World Forum for Harmonization of Vehicle Regulations

Proposal for Supplement 4 to 03 Series of Amendments to UN Regulation No. 100 (Electric power trained vehicles)

Submitted by the Working Party on Passive Safety*

The text reproduced below was adopted by the Working Party on Passive Safety (GRSP) at its seventy-fifth session (ECE/TRANS/WP.29/GRSP/75, para. 18). It is based on GRSP-75-01-Rev.3. It is submitted to the World Forum for Harmonization of Vehicle Regulations (WP.29) and to the Administrative Committee (AC.1) for consideration at their November 2024 sessions.

Figure 1
Schematic to Measure Wrap-Around Distance

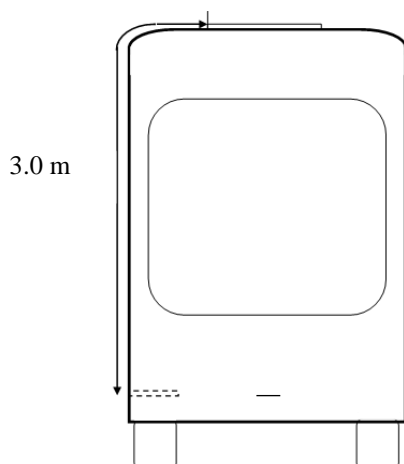
For vehicles of categories N₂, N₃, M₂, M₃, O₃ and O₄, conductive connection devices not energized except during charging of the REESS are exempted from this requirement if located on the roof of the vehicle out of reach for a person standing outside of the vehicle and, for vehicles of category M₂ and M₃, the minimum wrap around distance from the instep of the vehicle to the roof mounted charging devices is 3 m. In case of multiple steps due to an elevated floor inside the vehicle, the wrap around distance is measured from the bottom most step at entry, as illustrated in Figure 1."

Figure 1
Generic description of test pulses

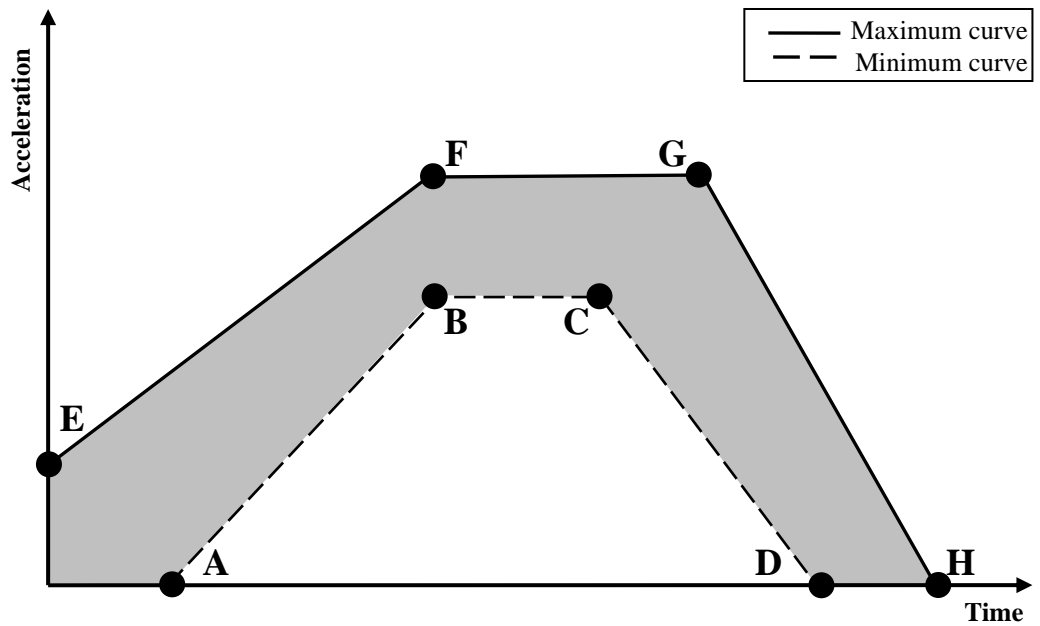
Annex 9C, paragraphs 3.2., amend to read:

The Tested-Device shall be decelerated or accelerated in compliance with the acceleration corridors which are specified in Tables 1 to 3. The manufacturer shall decide whether the tests shall be conducted in either the positive or negative direction or both.

The test pulse shall be within the minimum and maximum value as specified in Tables 1 to 3. A higher shock level and /or longer duration as described in the maximum value in Tables 1 to 3 can be applied to the Tested-Device if recommended by the manufacturer.

Table 1 for M₁, N₁, O₁ and O₂ vehicles¹:

Point	Time (ms)	Acceleration (g)	
		Longitudinal	Transverse
A	20	0	0
B	50	20	8
C	65	20	8
D	100	0	0

E	0	10	4.5
F	50	28	15
G	80	28	15
H	120	0	0

Table 2 for M₂ and N₂ vehicles:

Point	Time (ms)	Acceleration (g)	
		Longitudinal	Transverse
A	20	0	0
B	50	10	5
C	65	10	5
D	100	0	0
E	0	5	2.5
F	50	17	10
G	80	17	10
H	120	0	0

Table 3 for M₃, N₃, O₃, O₄ vehicles:

Point	Time (ms)	Acceleration (g)	
		Longitudinal	Transverse
A	20	0	0
B	50	6,6	5
C	65	6,6	5
D	100	0	0
E	0	4	2.5
F	50	12	10
G	80	12	10
H	120	0	0
